Item Name: Heli-Utility-Basket (Automatic Lid Opener)

DART SERVICE INSTRUCTION

TO AMEND DRAWING D350-607 REV. F OR SUBSEQUENT APPROVED REVISION

THE PURPOSE OF THIS DART SERVICE INSTRUCTION (DSI), IS TO PROVIDE OPERATORS OF AS350 / 355 ROTORCRAFT EQUIPPED WITH DART D350-607-041 HELI UTILITY BASKETS WITH AN UPGRADE KIT TO REPLACE THE EXISTING LID PROP ARM WITH 2 GAS SPRINGS.

FIGURE 1

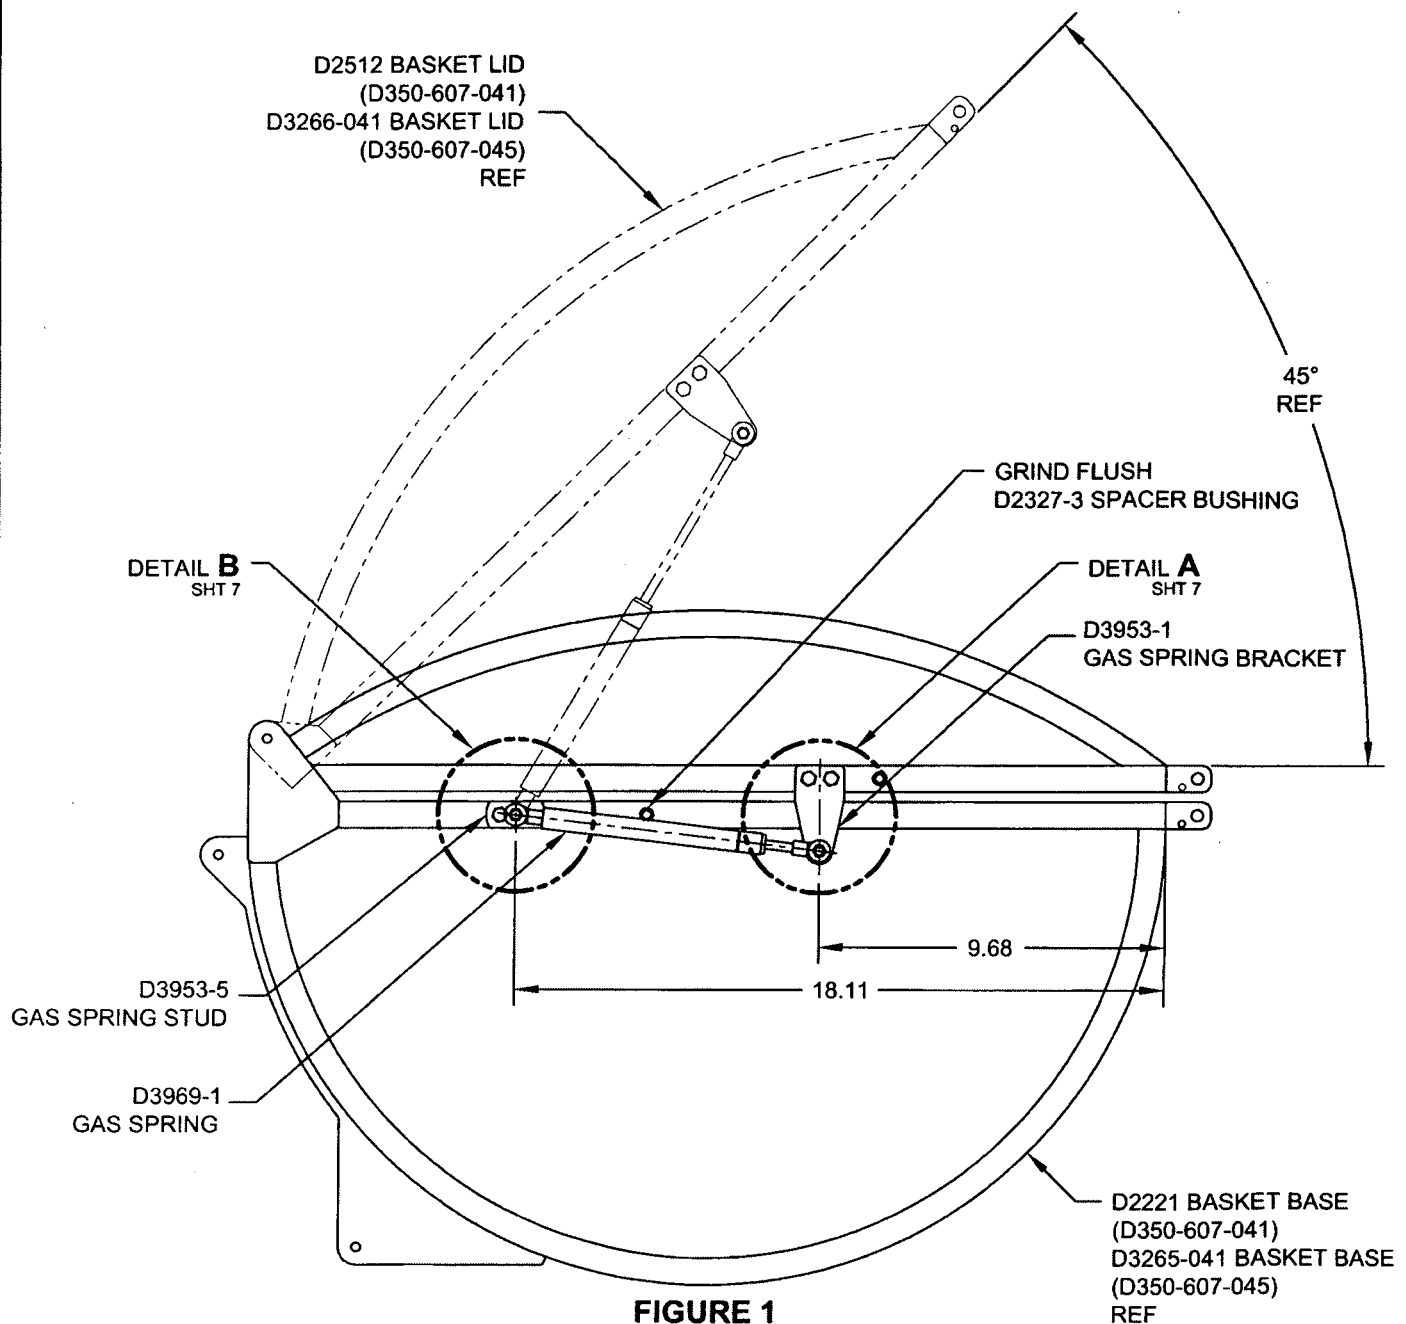
FOR D350-607-041 BASKETS, REPLACE THE EXISTING D2332-041 PROP ARM ASSEMBLY AS FOLLOWS:

- 1) REMOVE THE D2332-041 PROP ARM.
- 2) GRIND FLUSH THE D2327-3 SPACER BUSHING ON BOTH ENDS OF THE BASKET AS SHOWN IN FIGURE 1 (IT IS PERMISSIBLE TO GRIND ALL 4 SPACERS FLUSH). TOUCH UP PAINT PER ICA-D350-607 REV. 0 SECTION 5.1 ITEM 4.

- 3) LOCATE THE D3953-1 GAS SPRING BRACKET AS SHOWN IN FIGURE 1. TRIM STEEL MESH LOCALLY AS REQUIRED. TOUCH UP PAINT PER ICA-D350-607 REV. 0 SECTION 5.1 ITEM 4. TRANSFER MARK AND DRILL 2X Ø0.194 HOLES THRU THE BASKET LID SQUARE TUBE STRUCTURE AS SHOWN IN DETAIL A. INSTALL THE D3953-1 GAS SPRING BRACKET & D3953-13 GAS SPRING SPACER USING 2X AN3C16A BOLT, 2X NAS1149C0332R WASHER & 2X MS21043-3 NUT AS SHOWN IN VIEW E-E.

- 4) LOCATE THE D3953-5 GAS SPRING STUD AS SHOWN IN FIGURE 1. TRIM STEEL MESH LOCALLY AS REQUIRED. TOUCH UP PAINT PER ICA-D350-607 REV. 0 SECTION 5.1 ITEM 4. TRANSFER MARK AND DRILL 2X Ø0.194 HOLES THRU THE BASKET BASE SQUARE TUBE STRUCTURE AS SHOWN IN DETAIL B. FASTEN D3953-5 IAW VIEW F-F USING 2X AN3C11A BOLT, 2X NAS1149C0332R WASHER & 2X MS21043-3 NUT.

FIGURE 2
D350-607-143 AUTOMATIC LID OPENER INSTALLATION
 (1 END ONLY)

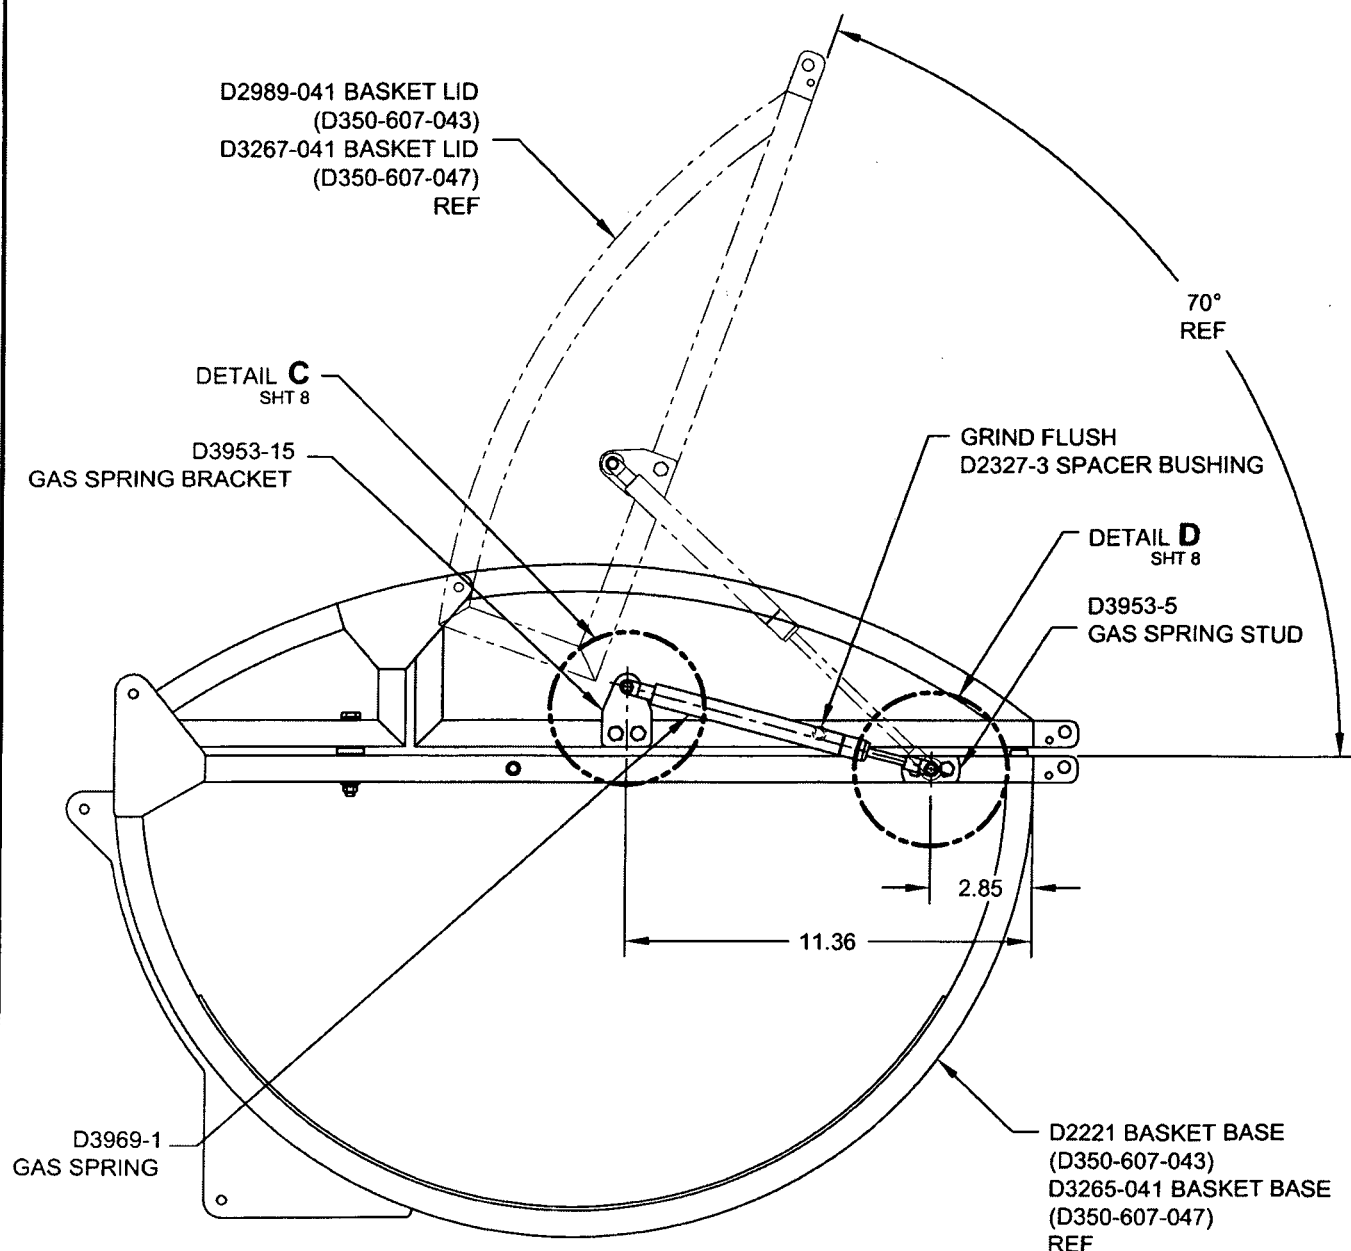
FOR D350-607-043/-047 BASKETS REPLACE THE EXISTING D2332-041 PROP ARM ASSEMBLY AS FOLLOWS:

- 1) REMOVE THE D2332-041 PROP ARM.
- 2) GRIND FLUSH THE D2327-3 SPACER BUSHING ON THE END OF THE BASKET WHERE THE LID OPENER IS BE INSTALLED AS SHOWN IN FIGURE 2 (IT IS PERMISSIBLE TO GRIND ALL 4 SPACERS FLUSH). TOUCH UP PAINT PER ICA-D350-607 REV. 0 SECTION 5.1 ITEM 4.

- 3) LOCATE THE D3953-15 GAS SPRING BRACKET AS SHOWN IN FIGURE 2. TRIM STEEL MESH LOCALLY AS REQUIRED. TOUCH UP PAINT PER ICA-D350-607 REV. 0 SECTION 5.1 ITEM 4. TRANSFER MARK AND DRILL 2X Ø0.194 HOLES THRU THE BASKET LID SQUARE TUBE STRUCTURE AS SHOWN IN DETAIL C. INSTALL THE D3953-15 GAS SPRING BRACKET & D3953-17 GAS SPRING SPACER USING 2X AN3C15A BOLT, 2X NAS1149C0332R WASHER & 2X MS21043-3 NUT AS SHOWN IN VIEW G-G.

- 4) LOCATE THE D3953-5 GAS SPRING STUD AS SHOWN IN FIGURE 2. TRIM STEEL MESH LOCALLY AS REQUIRED. TOUCH UP PAINT PER ICA-D350-607 REV. 0 SECTION 5.1 ITEM 4. TRANSFER MARK AND DRILL 2X Ø0.194 HOLES THRU THE BASKET BASE SQUARE TUBE STRUCTURE AS SHOWN IN DETAIL D. INSTALL 2X AN3C11A BOLT, 2X NAS1149C0332R WASHER & 2X MS21043-3 NUT AS SHOWN IN VIEW H-H. INSTALL THE ROD END OF THE D3969-1 GAS SPRING ONTO THE D3953-3 GAS SPRING STUD USING 1X D3953-9 GAS SPRING WASHER, 1X NAS1149C0432R WASHER, 1X AN310-4 CASTELATTED NUT & 1X MS24665-212 COTTER PIN AS SHOWN IN VIEW H-H. INSTALL COTTER PIN PER MS33540 OR AC43.13 CHAPTER 7-127.
